TM Textiles & Garments Limited (Expansion Unit)

Kashor, Post: Hobibari, Thana: Bhaluka, Mymensingh
(24.293696, 90.365797)

15th March, 29th September & 13th October 2020

Floor load Plan of mezzanine

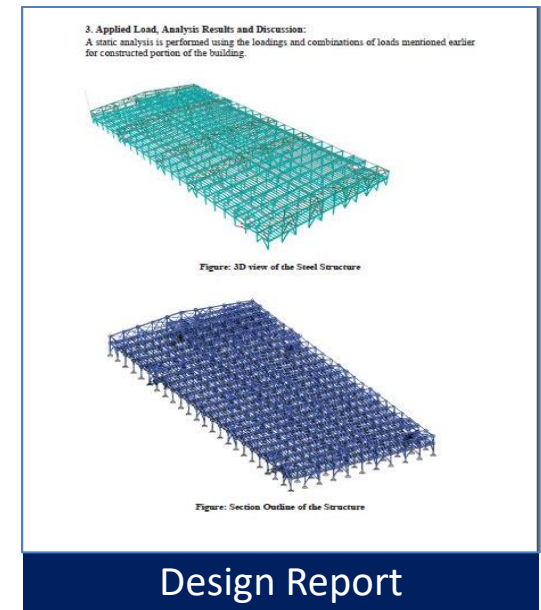
A set of load plan has been prepared for the main building considering 30psf live load for light storage on mezzanine floor. Which is not comply with BNBC. Prepared load plan need to be revised based on floor, column and foundation capacity.

A set of design report has been prepared for the main building considering 5 KPa (1st floor) live loading. Cursory calculation indicates that few columns under mezzanine floor are stressed above normal design limits considering 5 kPa live load on typical floor. On the other hand the material specification of steel member is not mentioned in the (provided PDF copy) design report as per BNBC section 1.9.1.1. Factory is required to revise and submit the design report with analysis file to RSC for further review.

Corrosion in steel member

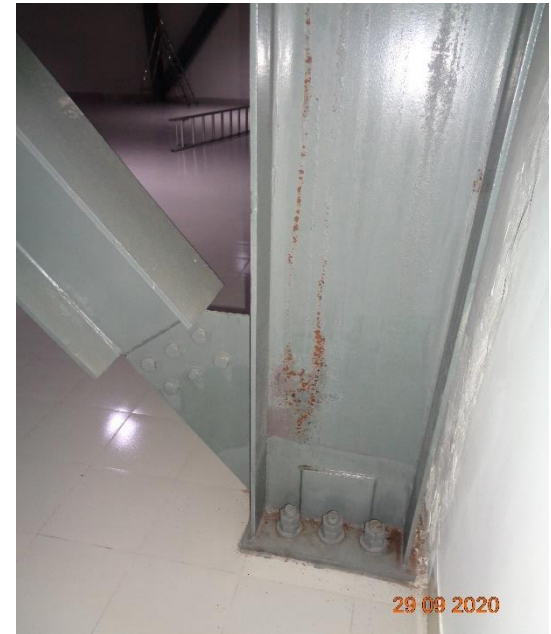
Corrosion in steel member was observed in various locations. The building engineer to investigate the reason of corrosion and suggest proper remedial measure accordingly.

Deck Slab from ground floor

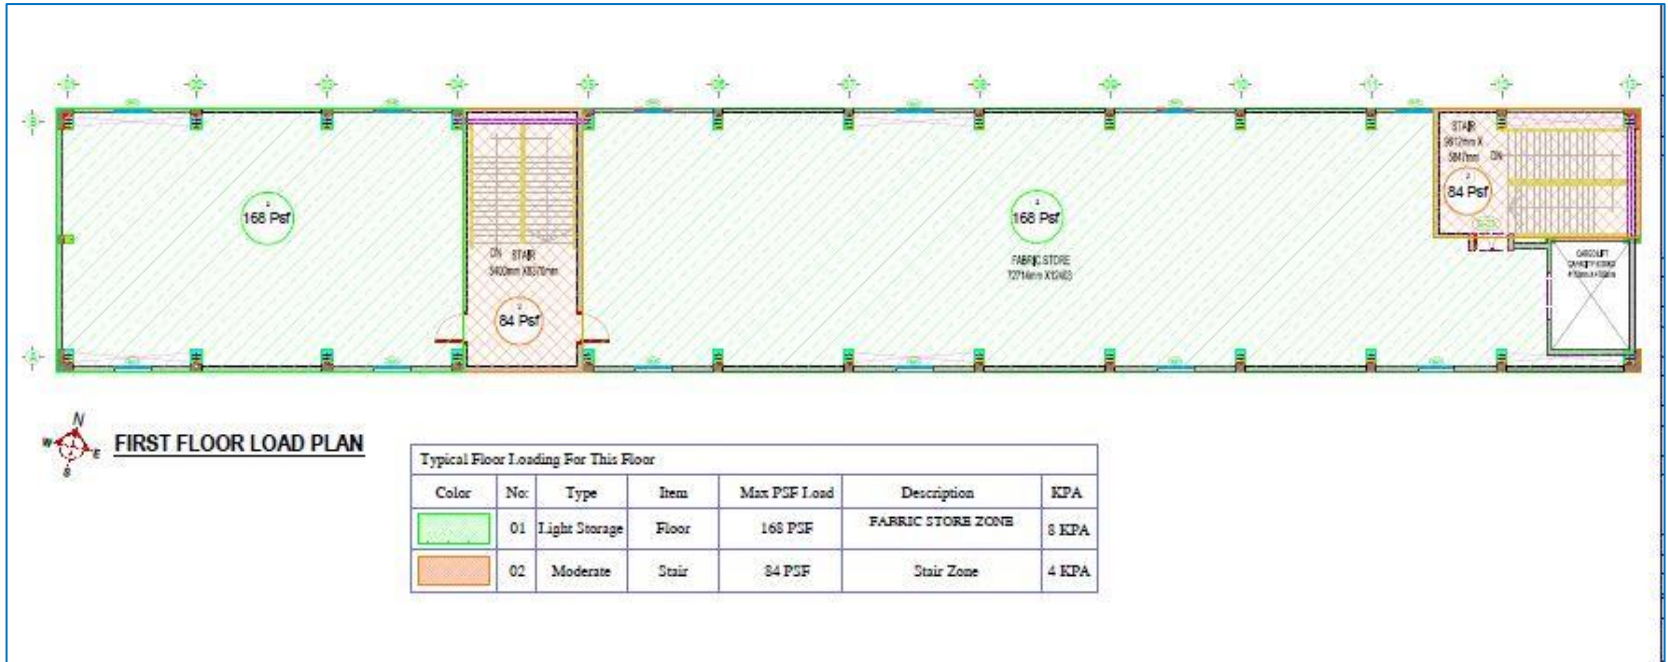
Information regarding the details of the deck slab was not available in the as-built drawings. The factory engineer is required to survey the structures and prepare as-built drawings complying with section 1.9.1.2 of BNBC.
